Chiller Department – Process Sheet

Universal 750

Ice Bank Controller replacement

629094962INS, Revision B; 12-18-2008

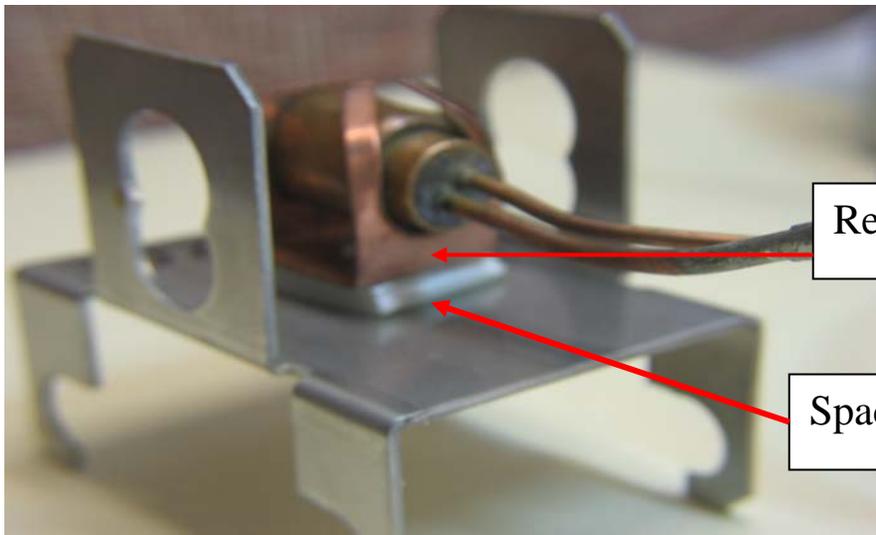
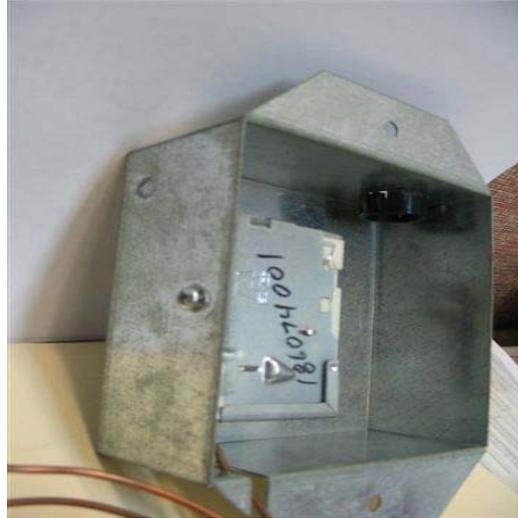
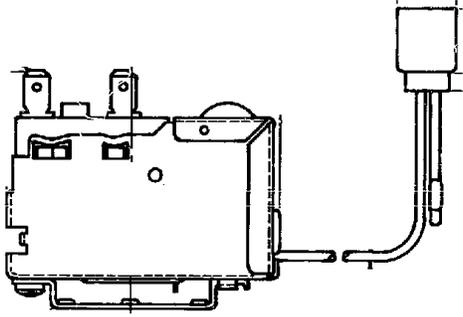
- 1) The new ice bank controller 186074001 (used in other applications) will replace controller 620314427
- 2) The mounting holes for the controller will align with an existing hole on the present electric box. Only one screw is needed due to the size and location of the controller
- 3) The sensing bulb will be affixed to the bracket using a spacer and retainer

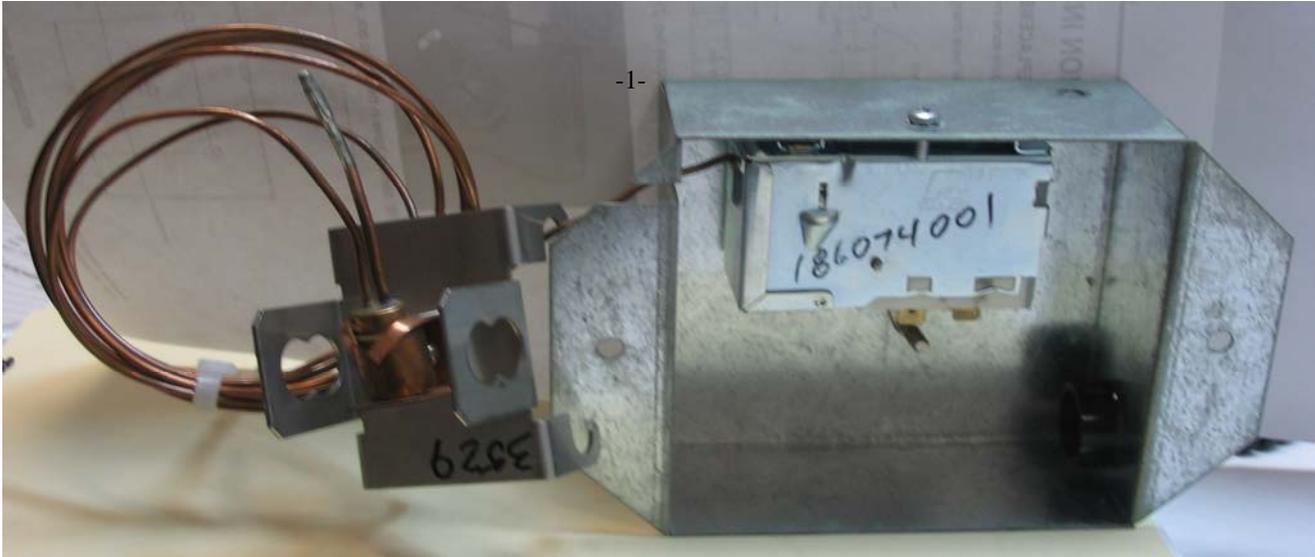
- 4) Disconnect power before servicing.
- 5) Remove the old controller and bulb, replace with the new controller.
- 6) Secure the bulb using the retainer, spacer, nut, and screw provided
- 7) The new bulb and bracket will locate at the same location as before.
